ADDENDUM 2

'Matilda Torres High School, Toros Stadium'
Matilda Torres High School
16645 Road 26. Madera, CA 93638

DARDEN PROJECT NO. 0622.4
DSA File Nos. 10-C3
DSA APPL. NO. 02-118396

The following additions, deletions, and revisions to the SHEETS and Project Manual are hereby made and do become a part of these Contract Documents.

AD2-SX01

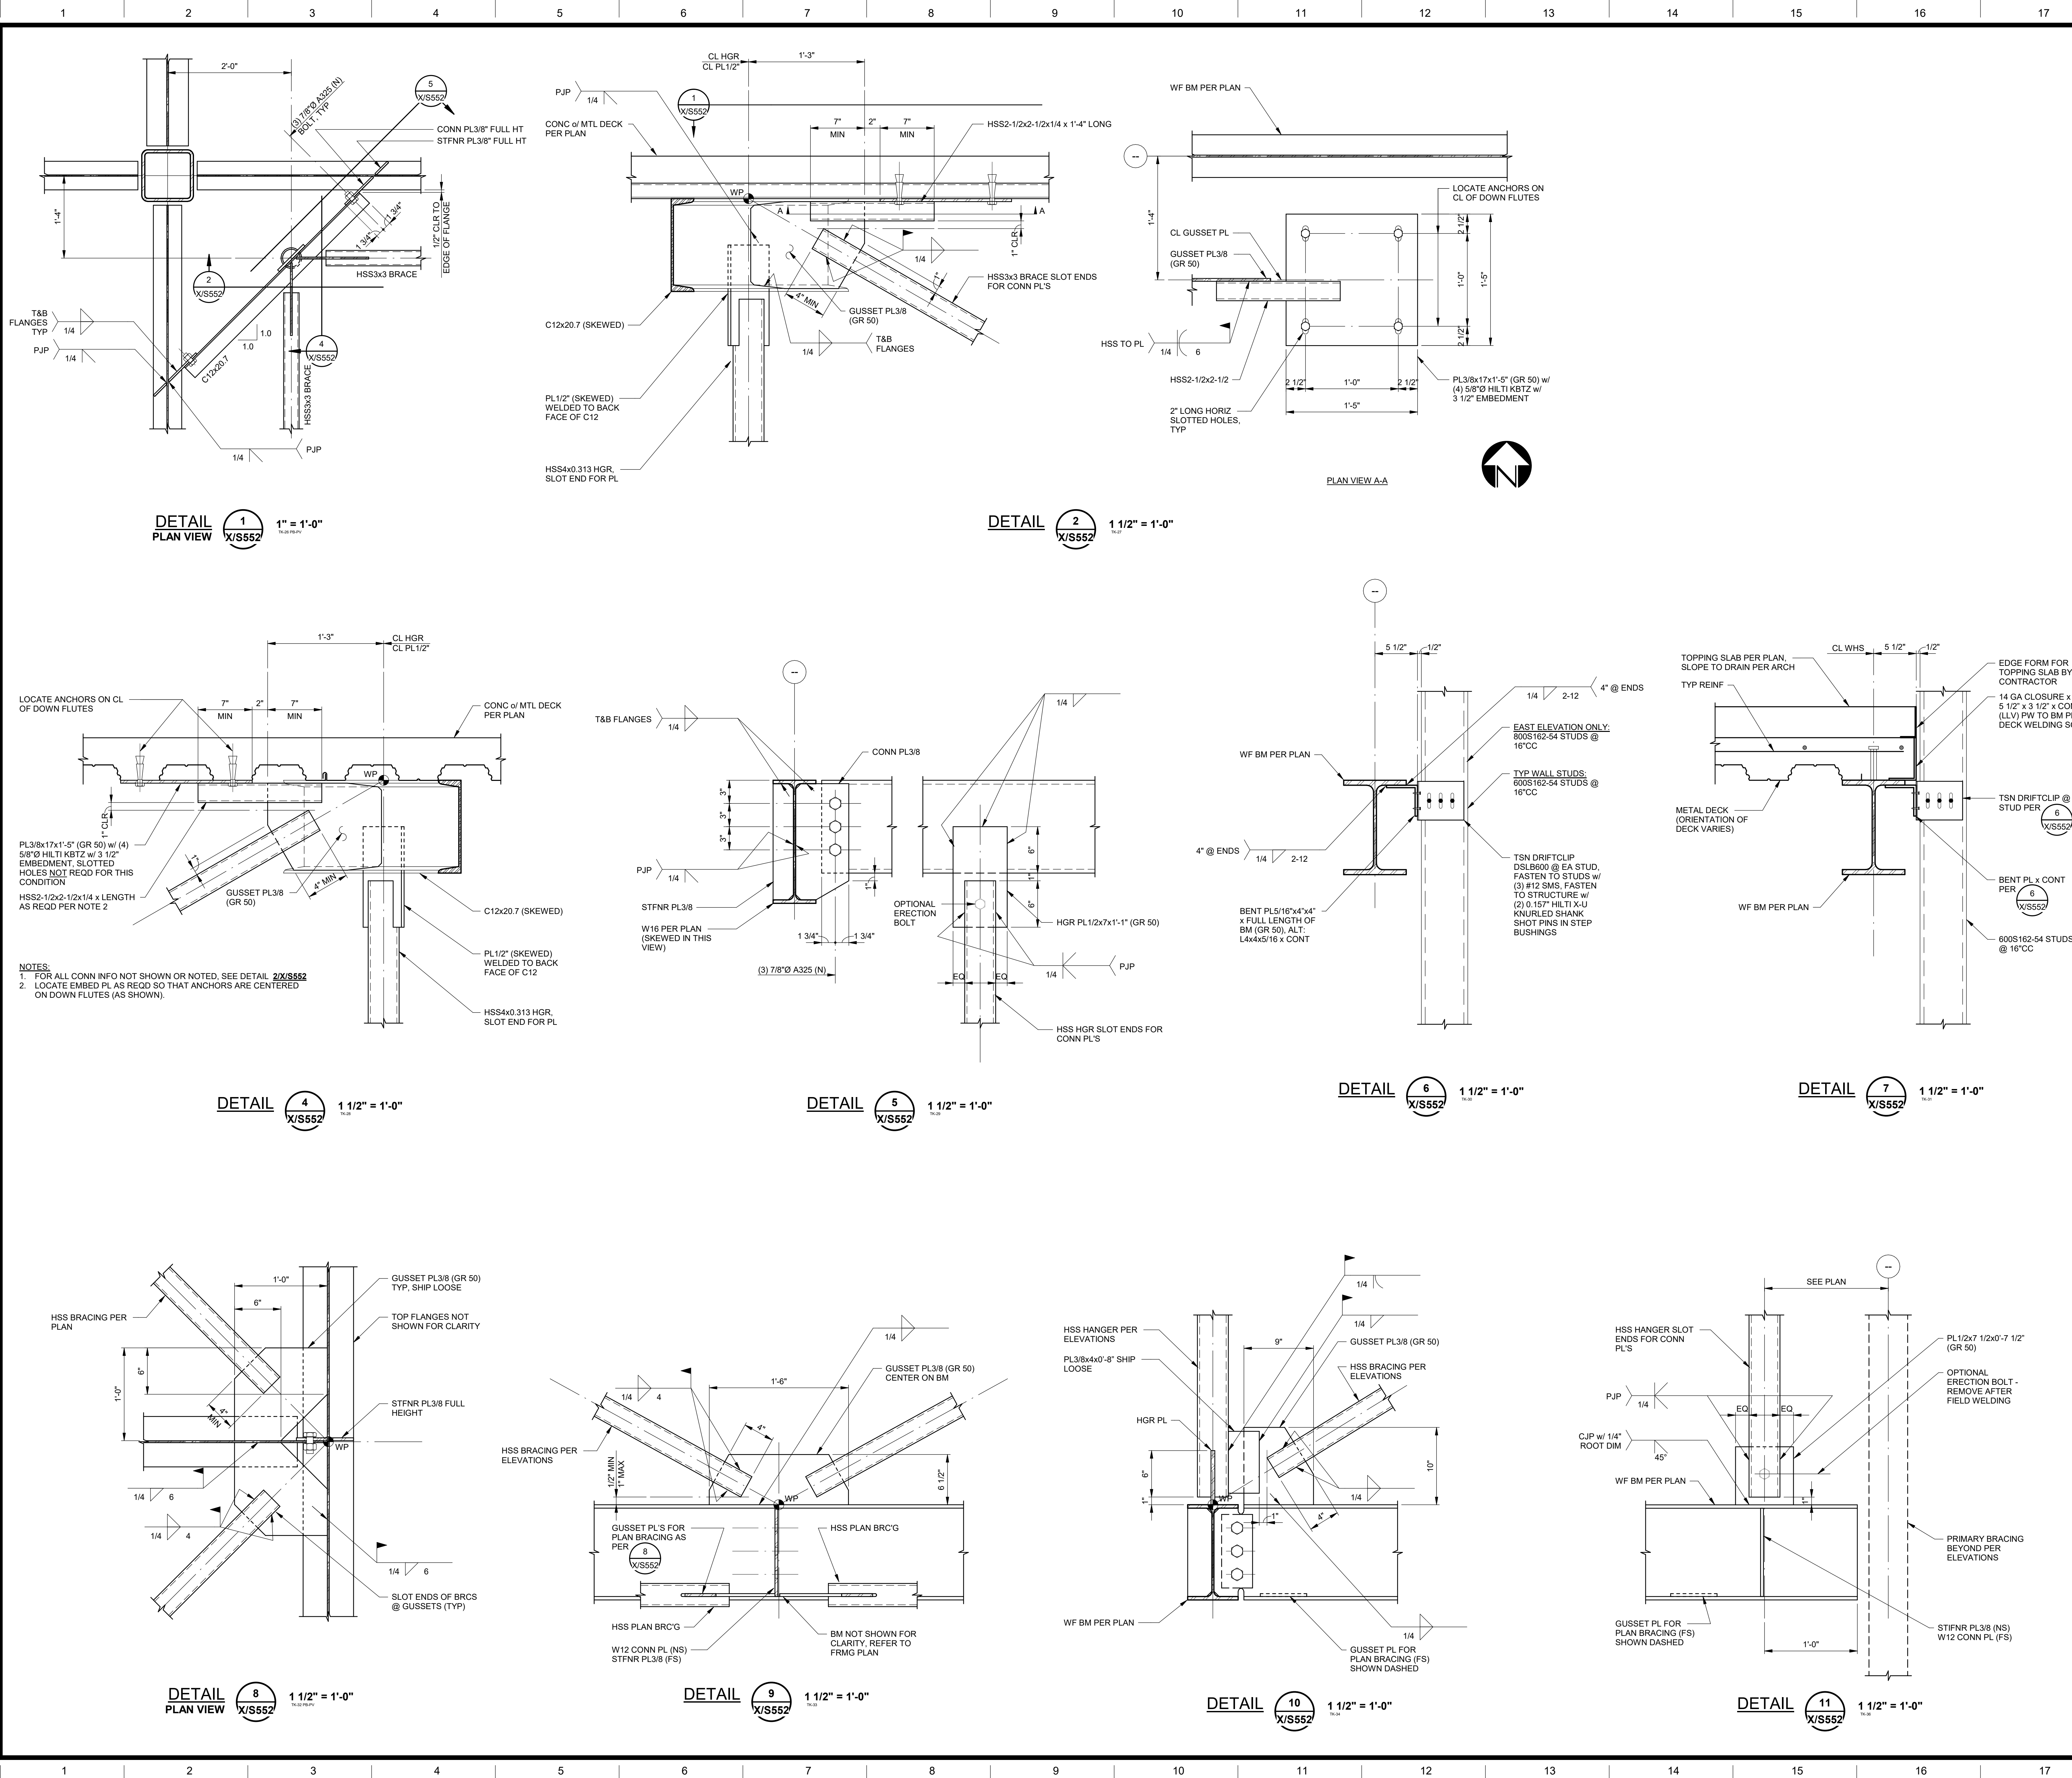
AD2-S01 Refer to Sheet SD/A552

1. Replace sheet SD/A552 with attached drawing AD2-SX01

1. Sheet X/S552 appears to be a duplicate of sheet X/S522. Please provide the correct X/S552 sheet.

See addenda 2 for corrected sheet X/S552
